IREDELL COUNTY HEALTH DEPARTMENT

IMPROVEMENT PERMIT / AUTHORIZATION TO CONSTRUCT / OPERATION PERMIT / EXISTING SYSTEM INSPECTION

PERMIT# 10708F PIN# 4767-76-3754 DATE 10-26-02

SUBDIVISION STONECREEK BLOCK / SECTION ____ LOT 12 LOT AREA 1.073 AC SITE CLASS. ____ DESIGN FLOW 360 L.T.A.R. .35

AS BUILT SKETCH

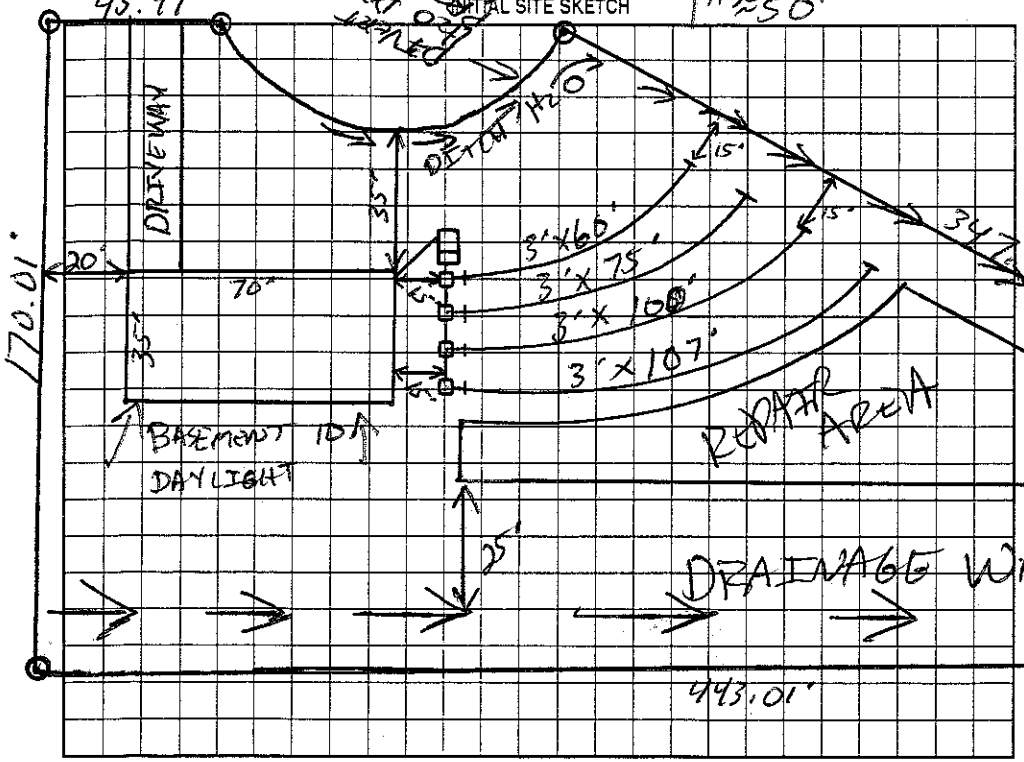
Comments/Conditions: (1) STUBOUT ABOVE NATURAL GRADE TO MAINTAIN FALL TO TANK. AT LEAST 15" AND BACKFILL. (2) RUN SURFACE H2O FROM DITCH DOWN PROPERTY LINE

Comments/Conditions: (3) INSTALL LINES ON CONTURE (4) MAINTAIN SETBACKS (5) HAVE SIDE PROPERTY LINE MARKED BY INSTALLATION. TUFF TIRE FILTER & MARKER, INSTALLED AS DRAWN

(*) DO NOT CUT OFF ANY SOIL THAT'S IN THE DRAIN LINE AREA. THE DRAIN LINES WERE CHECKED & HAD 12" OF COVER ON THE LOW SIDE. LINES ARE ON A 20% SLOPE SO REMOVING SOIL DUE TO LANDSCAPING COULD (*) TAKE PLACE VERY EASILY, BUT DO NOT ALLOW. SURFACE DIVERSION DITCH WAS 15' AS DRAWN AT TIME OF CHECK.
